PAVING PLANS						
YELLOWJACKET LANE						
GOLDENCREST						
CITY OF ROCKWALL.....ROCKWALL COUNTY, TEXAS						
HAROLD L. EVANS & CONSULTING ENGINEER						
DESIGN	DRAWN	DATE	SCALE	NOTES	FILE	NO.
DEJ	MLP T.L.D.	MAY, 1985	1" = 40' H. 1" = 5' V.			82114-A

Rockwall High School
 Rockwall Independent School District
 801 East Washington Street
 Rockwall, TX 75087
 722-3201

SITE PLAN REVIEW

Agenda Item: P&Z 91-3-Z/SP/PP - Hold Public Hearing and Consider Recommending Approval of a Request from the RISD for a Change in Zoning from "MF-15", Multifamily, to "C", Commercial, and Approval of a Site Plan and Preliminary Plat on a Tract of Land Located on Yellowjacket Lane East of FM-740

site plan

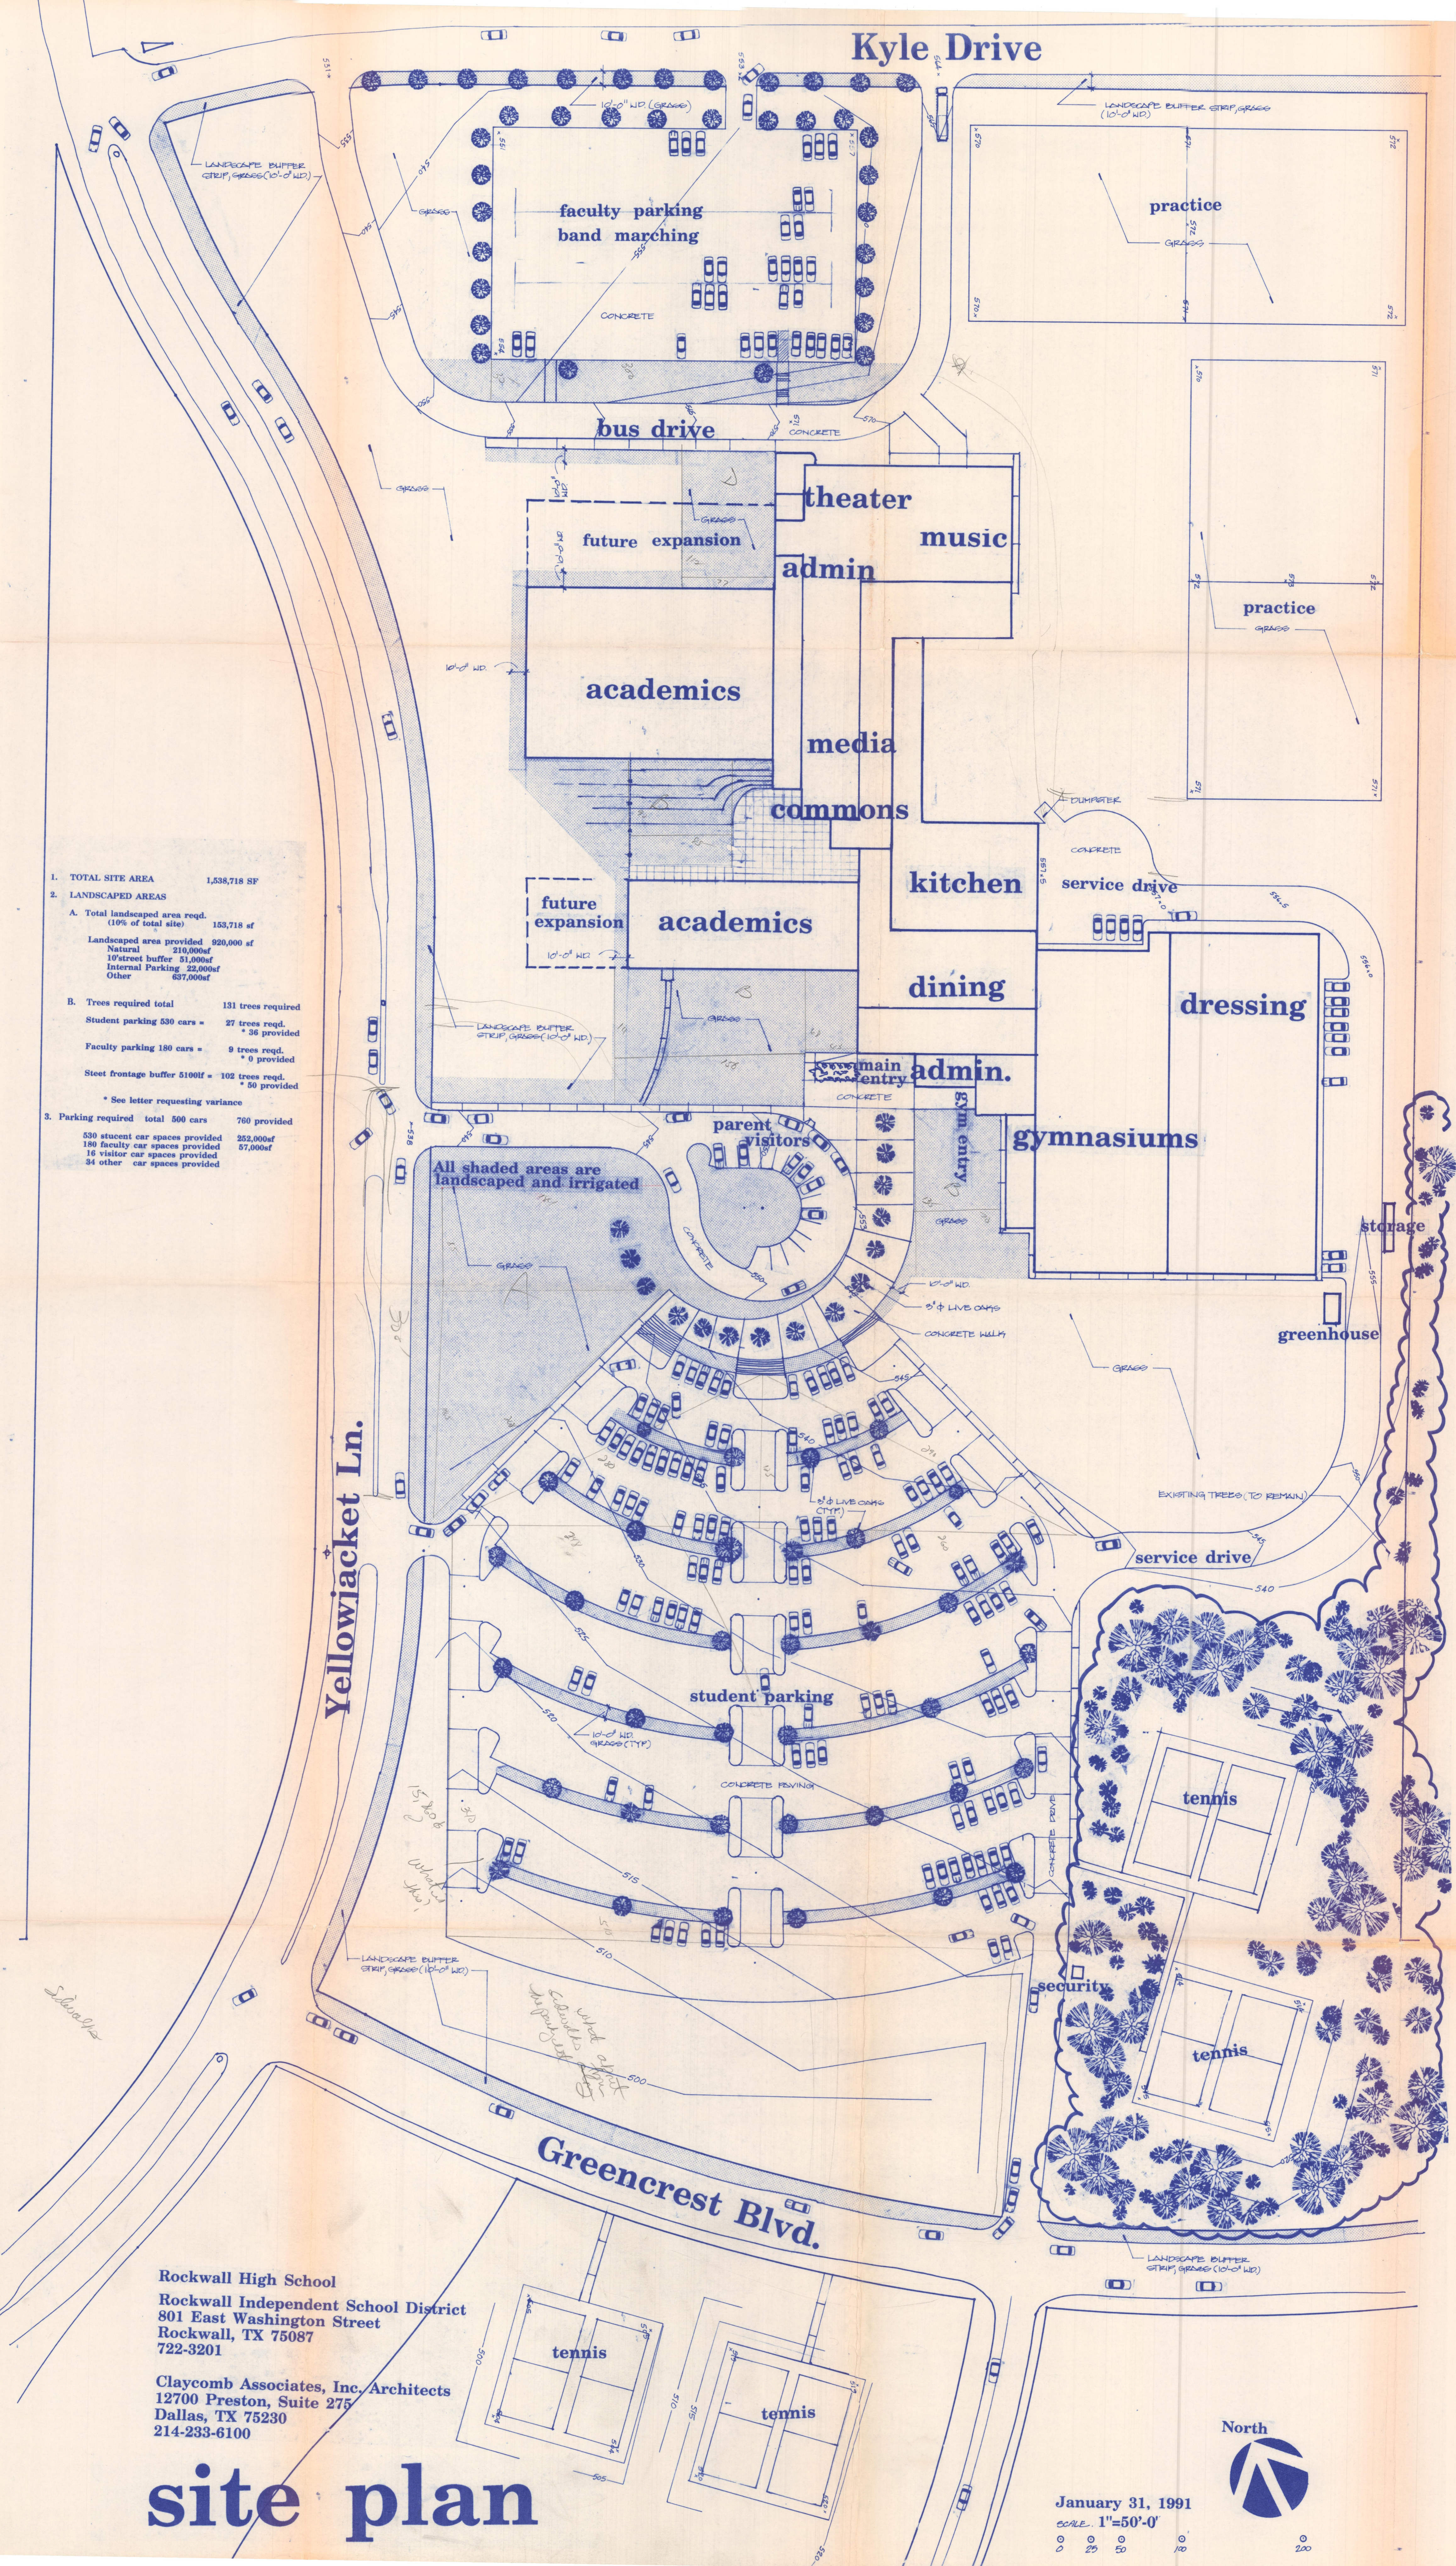
| h. | Is adequate area in landscaping shown? | ☐ | ☒ | ☐ |
| i. | Is it irrigated? <i>need 15% impervious</i> | ☐ | ☐ | ☐ |
| k. | Are types of landscaping indicated? | ☐ | ☒ | ☐ |
| l. | Is floor area ratio correct? <i>need a landscaping plan</i> | ☒ | ☐ | ☐ |
| n. | Are correct number of parking spaces provided? <i>check on no. of students</i> | ☐ | ☐ | ☐ |
| r. | Is a fire lane provided? <i>it is short on the back side but does allow the</i> | ☒ | ☐ | ☐ |
| |Do drive entrances line up with planned median breaks? <i>being reviewed</i> | ☐ | ☒ | ☐ |
| x. | Are sidewalks provided? <i>need to provide</i> | ☐ | ☒ | ☐ |

The site plan details the proposed layout for the school. The site plan is generally in conformance with the City's requirements. Our comments are as follows:

Landscaping - the plan provides the required percentage of irrigated landscaping. They have not completed a detailed landscaping plan at this point. They propose to complete a plan for submission to the Commission and Council at a later date. The School is asking for a waiver to the parking lot landscaping in the faculty parking lot. The school will use this parking area for marching band practice as well as parking and internal landscaping will interfere with this type of use. They have exceeded the required landscaping in the student parking area and they propose to screen the faculty parking lot with shrubs. The school is also proposing to use some of the existing trees around the tennis courts for their street tree requirement. This is an issue we would need to review when they do submit the detailed landscaping plan.

Site Access - the site plan provides for access into the student parking lot from Yellowjacket and from Greencrest. There is also access off of Yellowjacket proposed for the parent drop off area in front of the building. Both of these points of access propose to utilize a median break. John Reglin has reviewed the proposed median breaks and indicated some concern about the lack of separation between the parent drop off drive and the student parking lot drive on Yellowjacket. The Commission will review this issue Thursday night.

The access into the faculty parking lot is off of Kyle Drive, which is currently only half of a street. Both the school and the City recognize the need to widen and /or extend Kyle along the school's property line. The school is also interested in extending Kyle all the way to the service road to improve circulation around the site. We would recommend that a condition be placed on the site plan that Kyle be expanded prior to completion of the school.

Sidewalks - the City's subdivision regulations require that sidewalks be provided on all streets on the City's thoroughfare plan. All of the streets in this development are on the thoroughfare plan and would require sidewalks unless otherwise approved. The school is requesting a waiver to the sidewalk requirements for their frontage along Greencrest. They do have frontage on both sides of Greencrest.

Fire Access - the site plan does not provide for a fire lane all around the building. The architect proposes to place one fire hydrant at the rear of the library area. Because they do not wish to extend the fire lane around the music room to tie into the rear drive we would recommend that an additional fire hydrant be placed off of the faculty driveway for a second means of accessing a fire hydrant.

Building - The school is planning to use a metal material in the front of the building that may not meet our masonry requirements without a CUP. The school is aware that if the material does not meet standards that an application will have to be made for a CUP.

- Landscaping - A requirement that a detailed landscaping plan be submitted for Commission approval prior to the completion of the high school. Such plan will address the number of street trees to be provided.

- Approval of the requested waiver to the parking lot landscaping in the faculty parking lot.
- Turn Lanes - As mentioned in the previous notes, there was some concern regarding the proximity of the two median breaks between the parent drop off area and the student access on Yellowjacket which, as we understand it, be used normally as an exit only. Mr. Reglin's concern was with the proposed turn lane into the student access. The median, as proposed, is too short to accommodate the turn lane into this area and provide a future turn lane into the property to the north. Another concern was that if the access is only to be used as an exit except for special after school events that might be a large traffic generator, the presence of the turn lane will not normally serve traffic and its presence will be confusing to the traveling public.

- 1) a detailed landscaping plan be submitted for approval prior to the completion of the high school
- 2) recommending a waiver to the landscaping requirement in the faculty parking lot

- 100 4) that Kyle Drive either be extended to tie into I-30 and become one way or be widened to the second bus drive (third entrance) for two way traffic prior to issuance of the certificate of occupancy and that a plan for the improvement of Kyle be submitted to the Planning and Zoning Commission by August 1991

- 10) that a sidewalk be added along on the north side of the drive between the student parking lot and Greencrest
